UNITED STATES PATENT AND TRADEMARK OFFICE

APPLICATION NO.	FILING DATE	FIRST NAMED INVENTOR	ATTORNEY DOCKET NO.	CONFIRMATION NO.
10/040,104	10/19/2001	Chun-Keng Hsu	67,200-531	8828

Office Action Summary	Application No.	Applicant(s) M	
	10/040,104	HSU ET AL.	
	Examiner	Art Unit	
	PAUL T. CHIN	3652

DETAILED ACTION

Fig. 3.

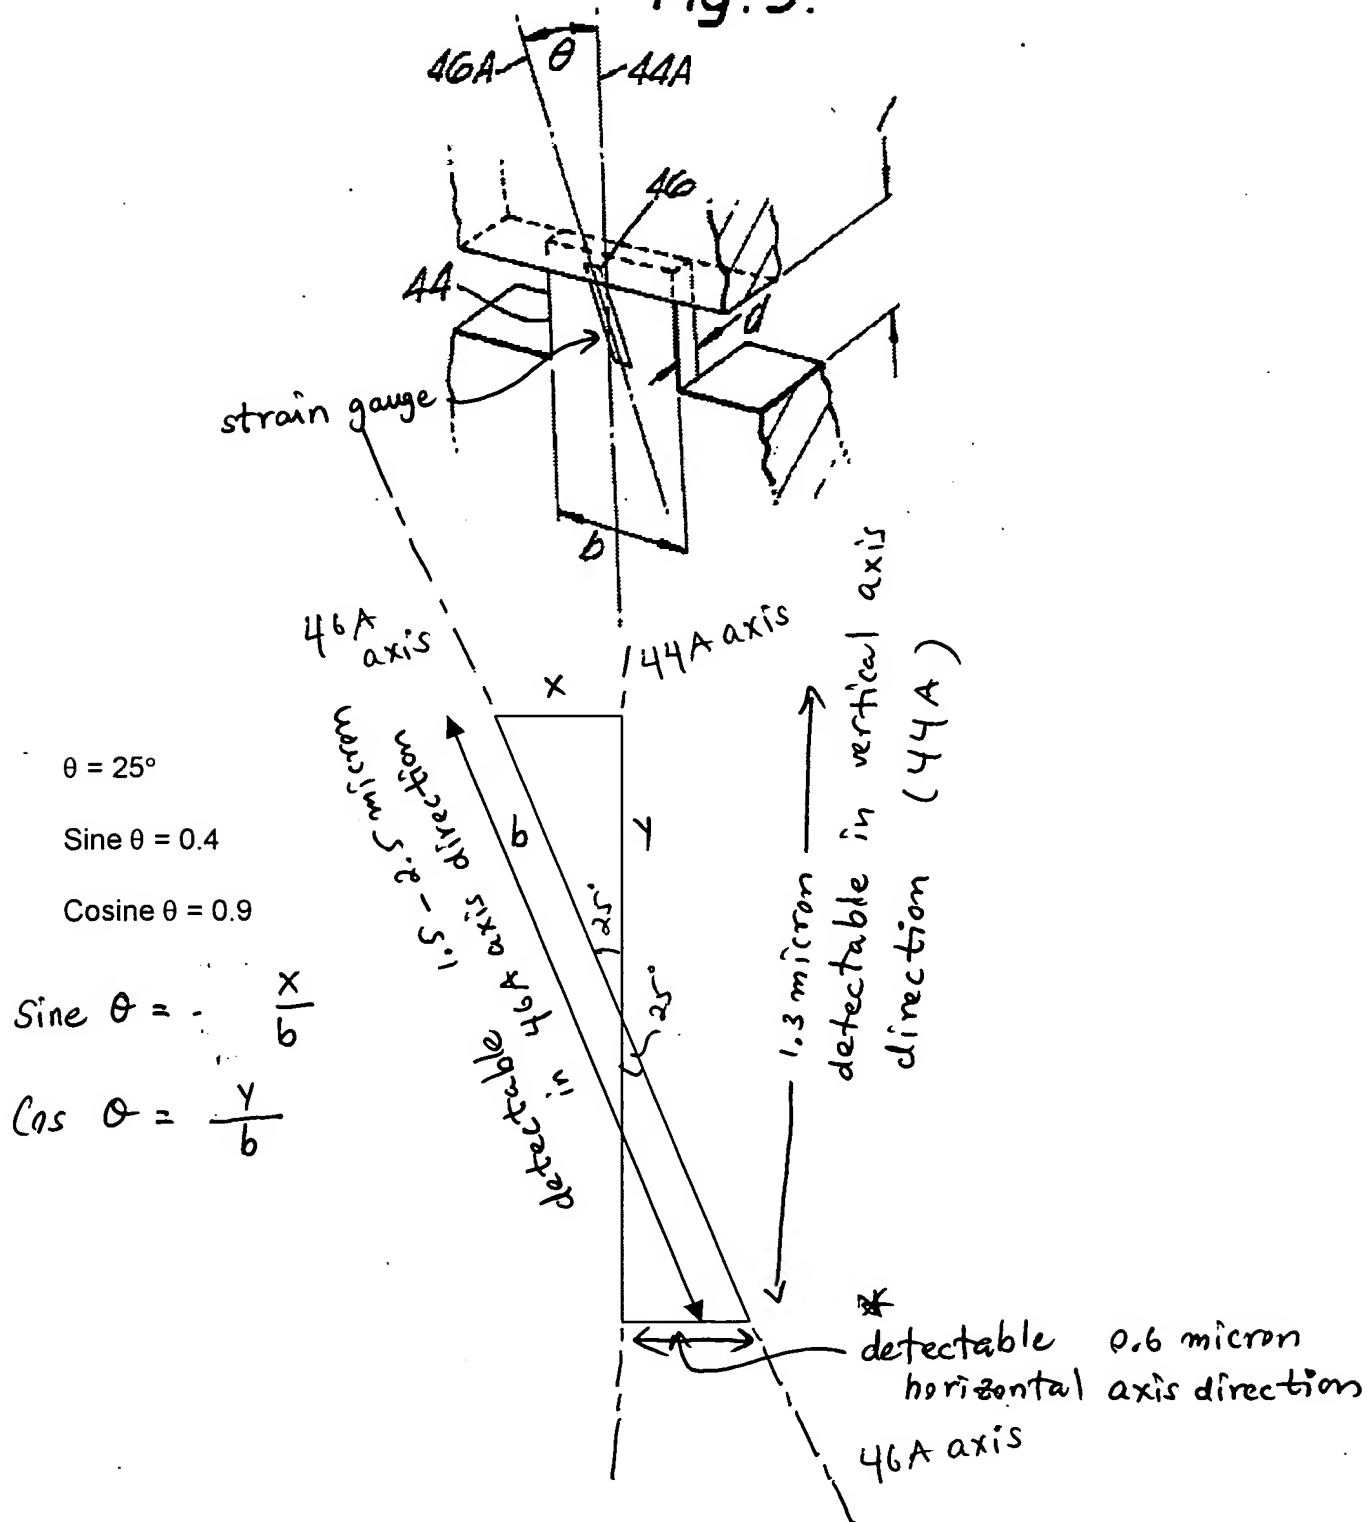
Applicant argues that "Hajdukiewicz et al. does not teach a sensor capable of detecting to a sensitivity of at least 1 micron displacement" (page 8). The arguments are not persuasive. Hajdukiewicz et al. shows a sensor (46) in the form of strain gauge capable of detecting a movement of two microns, plus or minus 0.5 micron (from Col 3, line 61, to Col 4, line 24) in the axis (46A) (see Fig. 3) as to whether the strain is tensile, compressive, or torsional or any combination thereof. It is pointed out that the strain gauge of Hajdukiewicz et al. is capable of detecting at least detectable at least 1.5 micron in the 46A axis direction, which is 25 degree angle from a vertical axis (44A) (see Fig. 3), is also capable of detecting at least 0.6 micron in the horizontal axis direction,

which is perpendicularly to the axis (44A) (if calculated as 1.5 micron multiplied by Sine 25, which is 0.4).
